Subject: Issuance of Amendment No.1 to Facility Operating License NPF-68
Vogtle Electric Generating Plant, Unit 1 (TAC 65068)

GEORGIA POWER COMPANY
OGLETHORPE POWER CORPORATION
MUNICIPAL ELECTRIC AUTHORITY OF GEORGIA
CITY OF DALTON, GEORGIA
DOCKET NO. 50-424
VOGTLE ELECTRIC GENERATING PLANT, UNIT 1
AMENDMENT TO FACILITY OPERATING LICENSE

Amendment No. 1
License No. NPF-68

SAFETY EVALUATION BY THE OFFICE OF NUCLEAR REACTOR REGULATION
RELATED TO AMENDMENT NO. 1 TO FACILITY OPERATING LICENSE NPF-68

FIGURE 3.1-2 REQUIRED SHUTDOWN MARGIN FOR MODE 5 (MODE 4 WITH NO RCPs RUNNING)

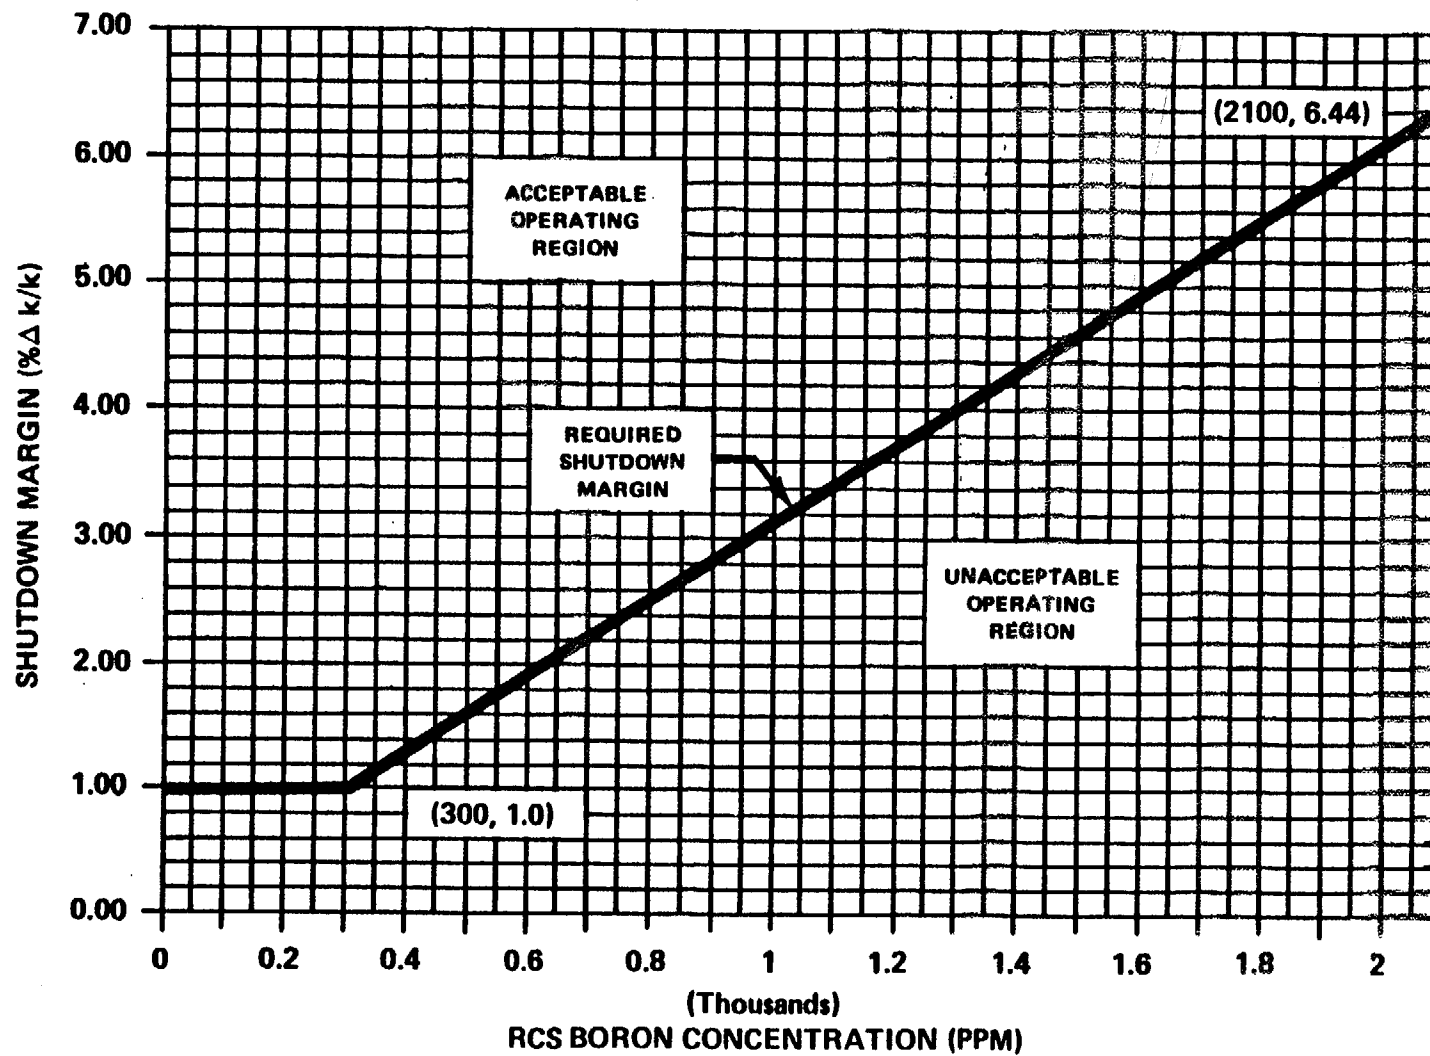
The amendment modifies the Technical Specifications to increase the shutdown margin requirements shown in Figure 3.1-2 and changes the title of that figure. The amendment is effective as of its date of issuance.

By letter dated March 30, 1987, Georgia Power Company, et al., (the licensee) requested a change to the Technical Specifications for Vogtle Electric Generating Plant, Unit 1. The change proposed would increase the shutdown margin requirements shown in Figure 3.1-2 and change the title of Figure 3.1-2. The proposed Figure 3.1-2 shows the required shutdown margin for Mode 4 when no reactor coolant pumps are in operation and for Mode 5 at all times. The boron dilution accident analysis is the basis for this curve. Westinghouse has recently revised its analysis methodology for analyzing boron dilution accidents, and the proposed change is a result of this reanalysis. The proposed title change would avoid confusion with Technical Specification Figure 3.1-1 and be consistent with Technical Specification 3.4.1.3.

Because of its review of the Diablo Canyon natural circulation test results, the NRC staff concluded that under low flow, natural circulation conditions, the water in the reactor vessel upper head could become stagnant and not actively mix with the remainder of the reactor coolant. Dissolved boron in the water within the upper head would not be available to mitigate the consequences of a boron dilution accident. The licensee took credit for the boron contained in the water within the reactor vessel upper head when the Final Safety Analysis Report boron dilution accident analysis was performed. Due to the revised NRC staff position, Westinghouse reanalyzed the Vogtle boron dilution accident for Modes 4 and 5 when no reactor coolant pumps are in operation. In the new analyses, no credit was taken for the boron in the water within the reactor vessel upper head.

For dilution events during hot standby, hot shutdown and cold shutdown (Modes 3, 4, and 5), Technical Specification 3.1.1.2 specifies the required shutdown margin as a function of RCS boron concentration. The specified shutdown margin ensures a minimum of 15 minutes from the time of the high flux at shutdown alarm to the total loss of shutdown margin. A reduction in the active mixing volume results in a reduction in time available for operator action. However, an increased boron requirement can be used to offset this reduction in time.

The boron dilution event for Vogtle was reanalyzed to exclude the water within the reactor vessel upper head, and the result was that a slightly higher boron concentration was needed to ensure the required 15 minute time requirement. The proposed Technical Specification Figure 3.1-2 reflects this slightly increased boron requirement. The Westinghouse reanalysis was performed with staff approved models.

The staff finds that the requested changes are acceptable because: (1) they are based upon analyses performed with approved methods and (2) the 15 minute time requirement will be satisfied with the proposed higher boron concentration. Further, the title change of Figure 3.1-2 is acceptable because it removes the overlap regarding pump operation which currently exists between Figures 3.1-1 and 3.1-2.
